<b>Office Action Summary</b>	<b>Application No.</b> 10/806,277	<b>Applicant(s)</b> WEBSTER ET AL.	
	<b>Examiner</b> AARON R. EASTMAN	<b>Art Unit</b> 4147

## **DETAILED ACTION**

**FIG-3****Figure 3 of Martin**

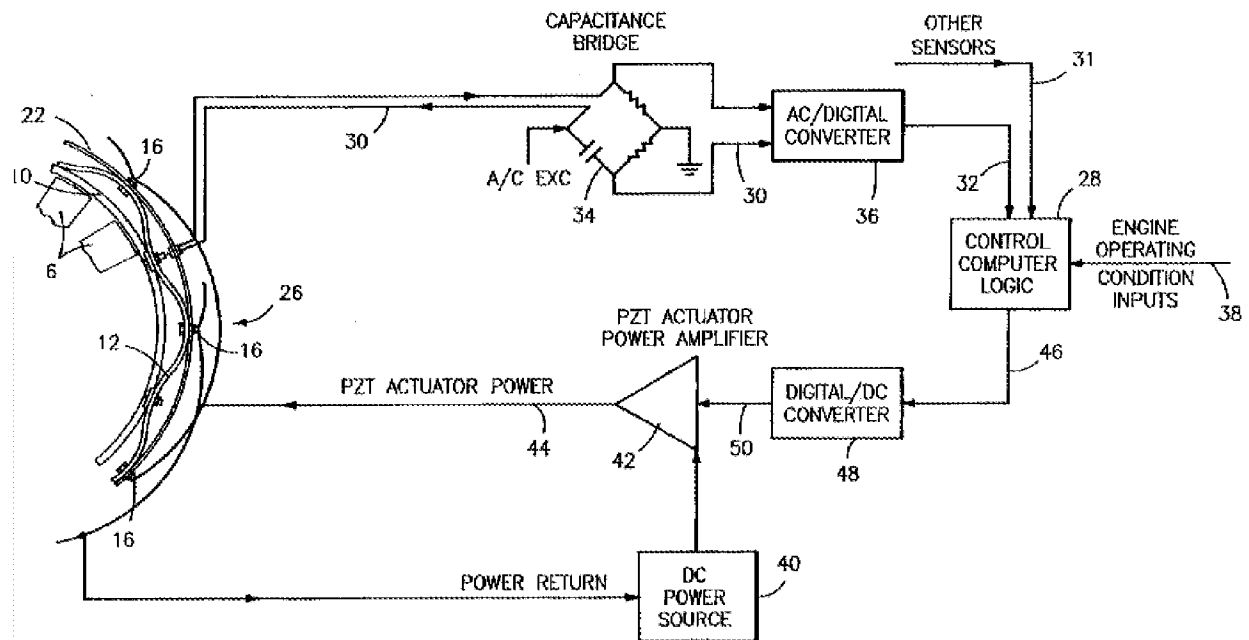
14. In re claim 14, Martin discloses means to measure (24) a clearance (D) between the lining (10) and the first member or the second member to produce a clearance signal indicative of the size of the clearance, processor means to determine if the clearance signal is within a predetermined range of clearances and means to adjust the clearance between the lining and the first member or second member if the processor means determines that the clearance signal is outside the predetermined range of clearances (see Figures 3 and 4 and col. 4 line 51 through col.5 line 51 of Martin).

15. In re claim 15, Martin discloses a means to measure the clearance comprising at least one capacitance sensor (see Figures 3 and 4 of Martin).

**Figure 1 of US Patent Number 6,547,522 (Turnquist et al. hereinafter)**

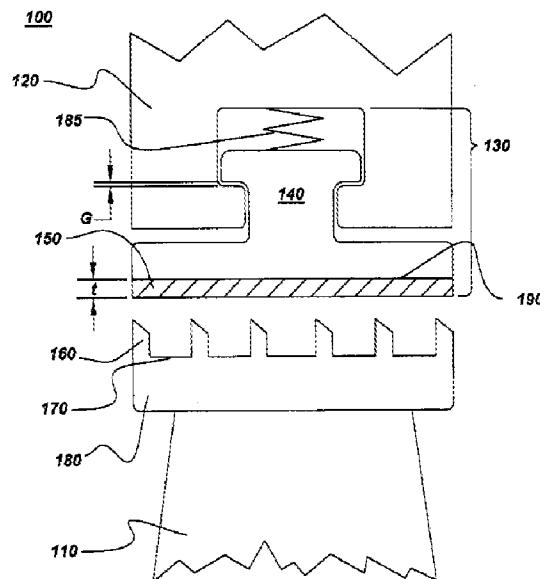
20. In re claim 8, 9 and 11 Martin and Garkawe disclose all of the limitations except for wherein the third member is Z-shaped in radial cross-section, the third member is resilient and the third member comprises a metal sheet.

21. Turnquist et al. teaches a seal between a rotor blade tip (160, first member) and a turbine casing (120, second member) comprising a spring (185, third member) disposed between the housing and the seal carrier segments, wherein the third member (185, Fig. 1) is Z-shaped in radial cross-section, the third member is a spring (col. 2 line 53) which is inherently resilient and the third member comprises a metal sheet (185, Fig. 2).
